SCHEMATIC CONDUIT DIAGRAM  
 OVER LEWES & REHOBOTH CANAL  
 SAVANNAH ROAD BRIDGE

SAVANNAH ROAD BRIDGE  
 LEWIS I. DEBEL  
 SCALE: AS LISTED  
 DATE: 1/21/83  
 PASCALE LEAF LIGHTING & POWER  
 TUDOR Z ELEC  
 DRAWING NUMBER  
 OFFICE COPY

HARDESTY & HANOVER  
 CONSULTING ENGINEERS  
 W. B. Burgess  
 MAY 2, 1983

# UPPER TROUGH

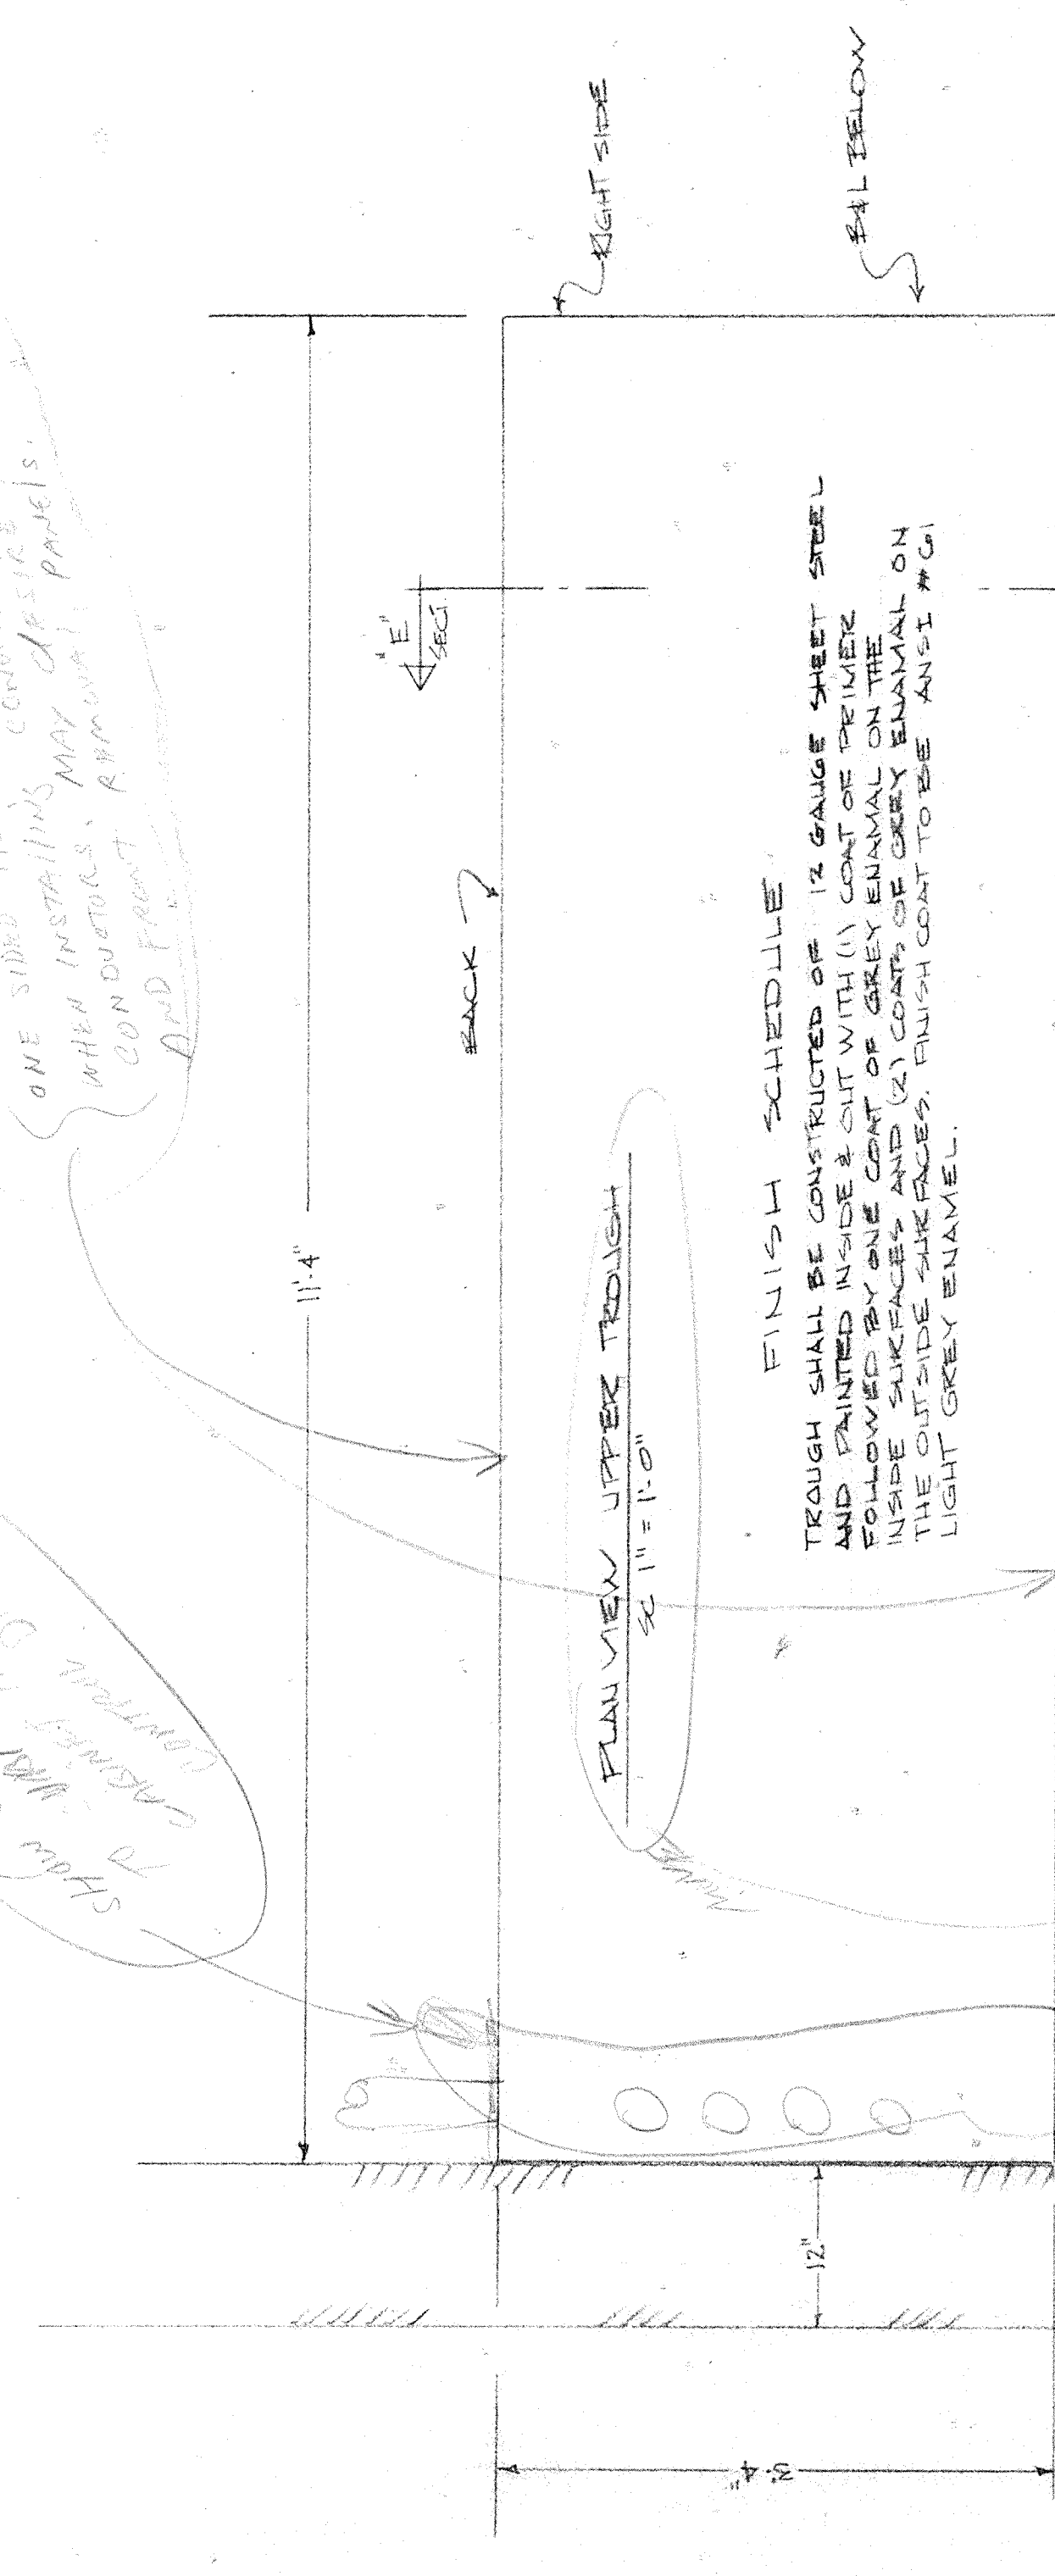
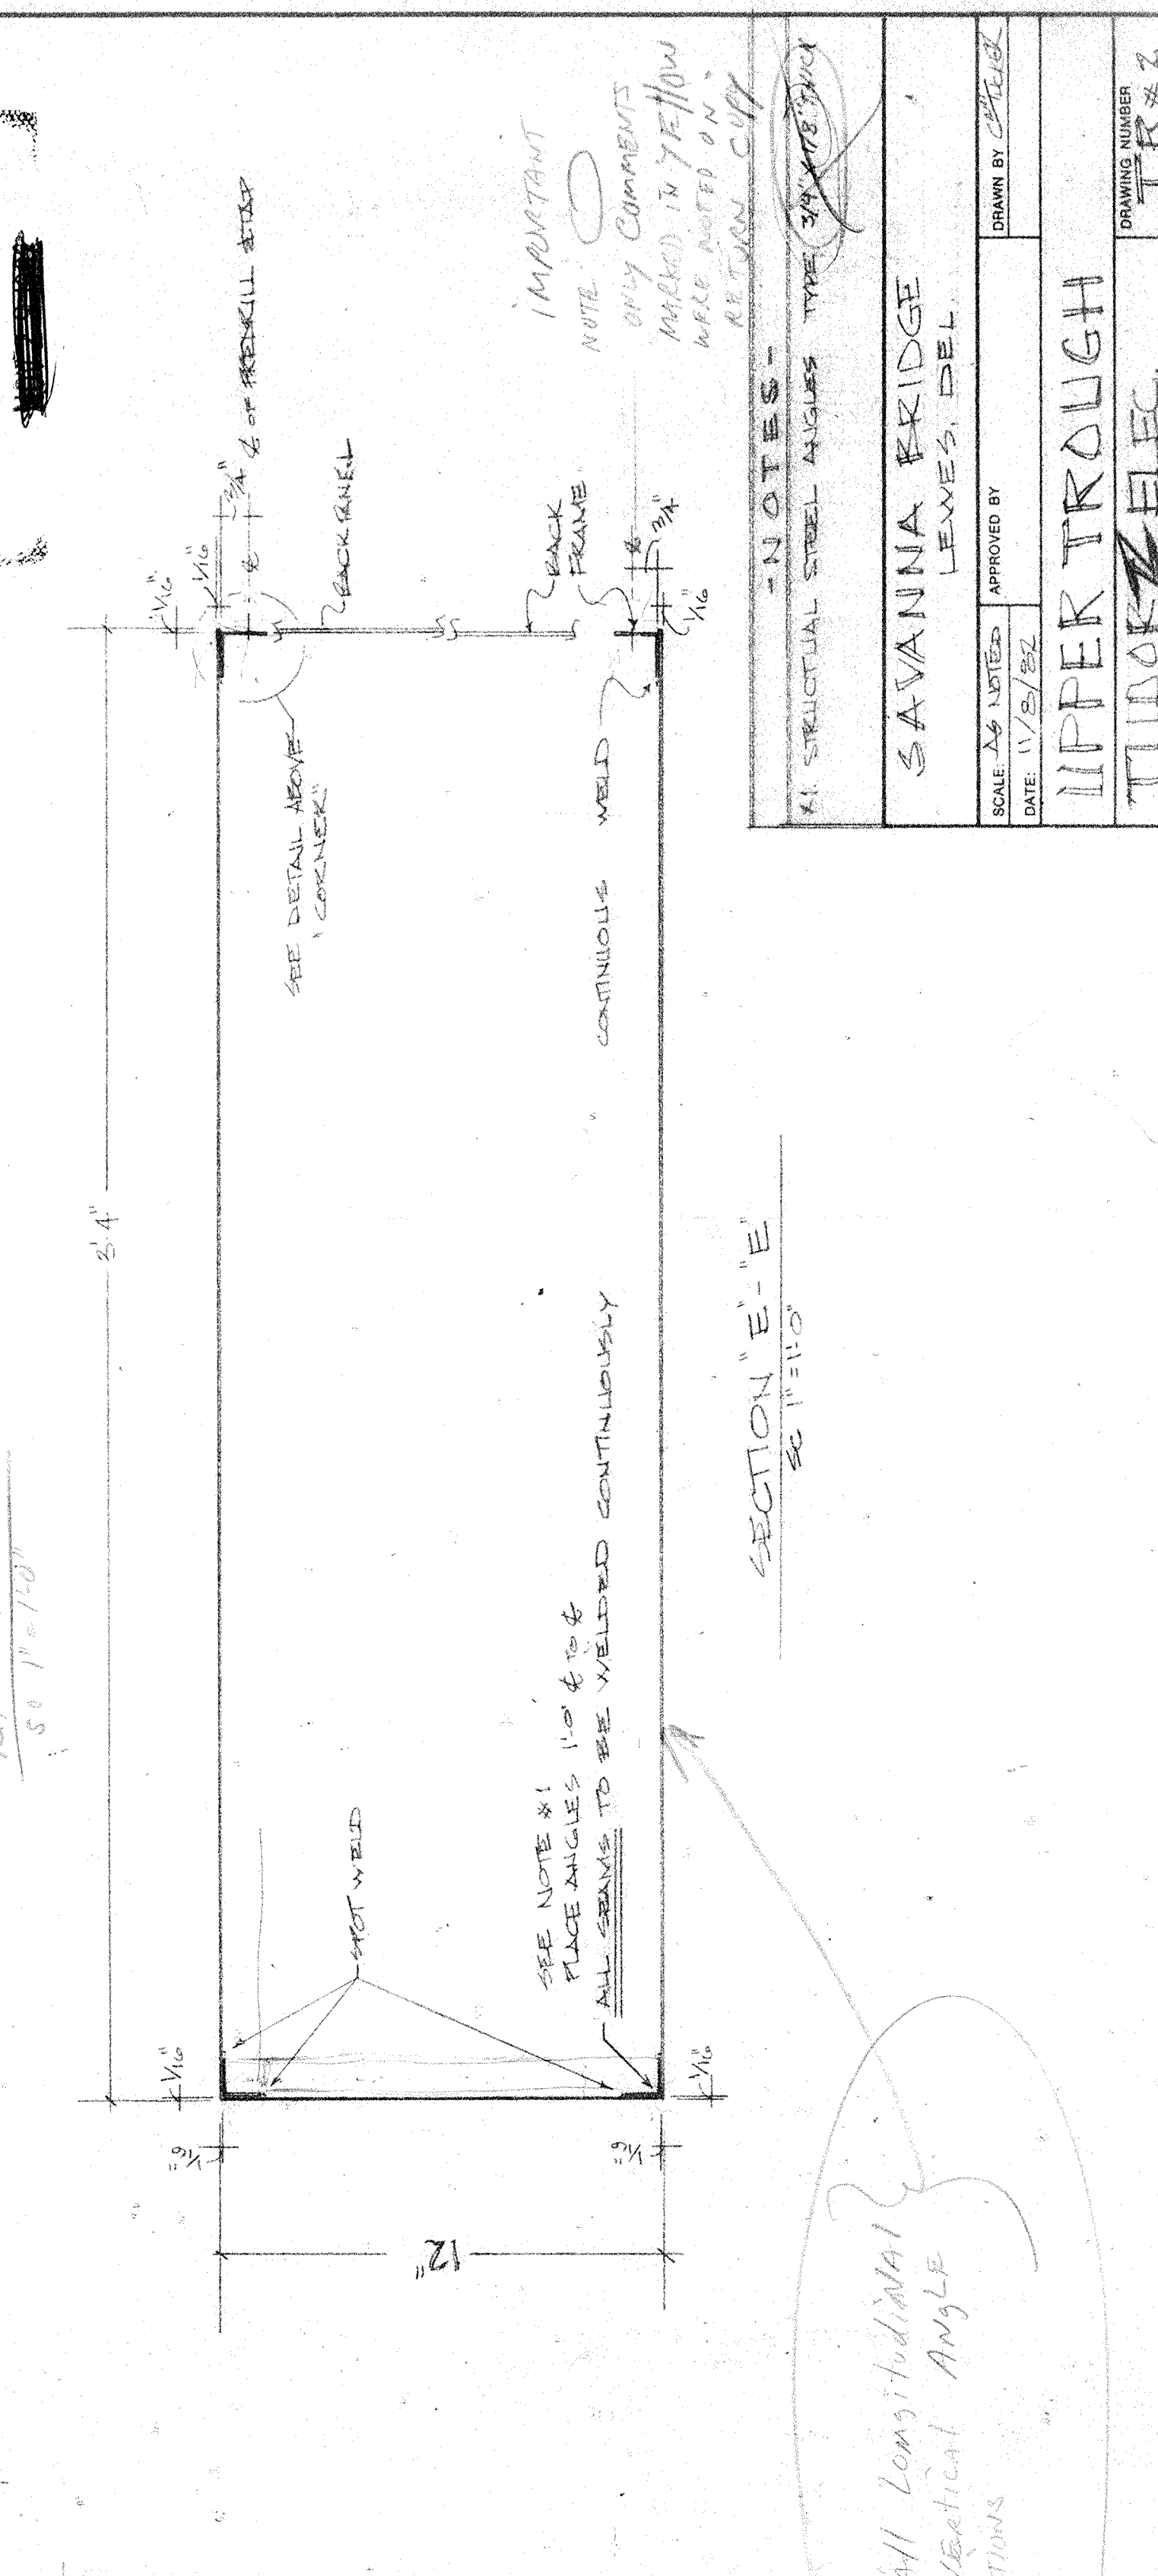
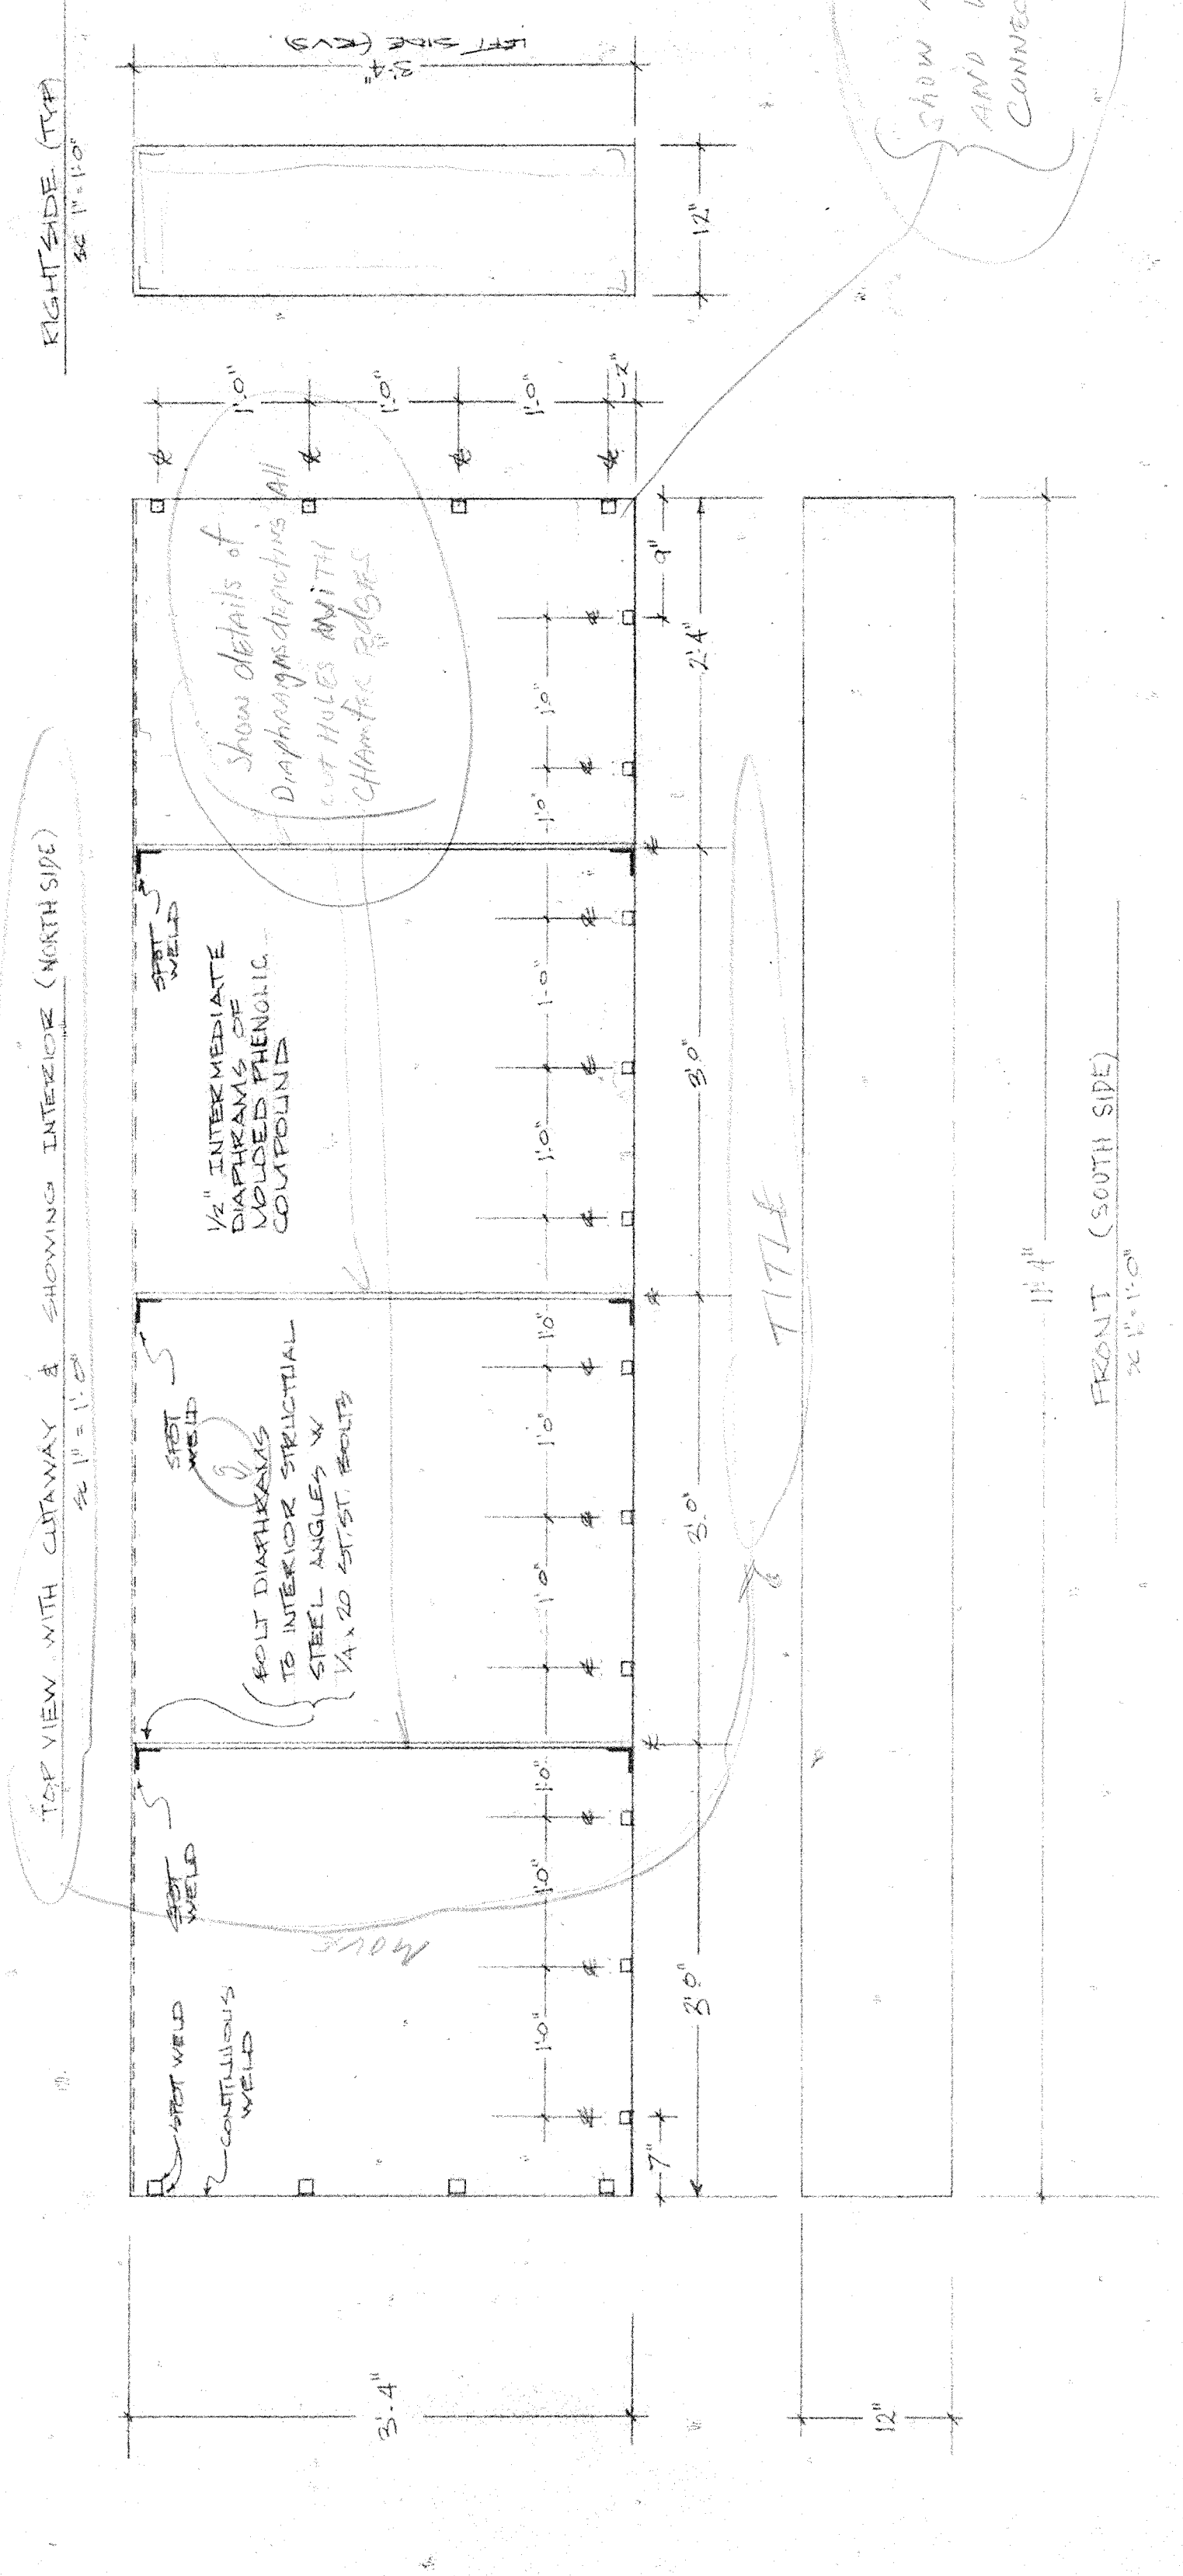
SHOW CONNECTIONS TO JOINTS AND TO CONTAIN DECK  
 ONE SIDE ACCESS MAY BE TRICKLE SOME  
 WITH INSTALLING CONDUITS AND BACK  
 CONDUITS APPROVAL PANELS  
 AND FRONT APPROVAL PANELS

SHOW ALL LONGITUDINAL AND VERTICAL ANGLE CONNECTIONS
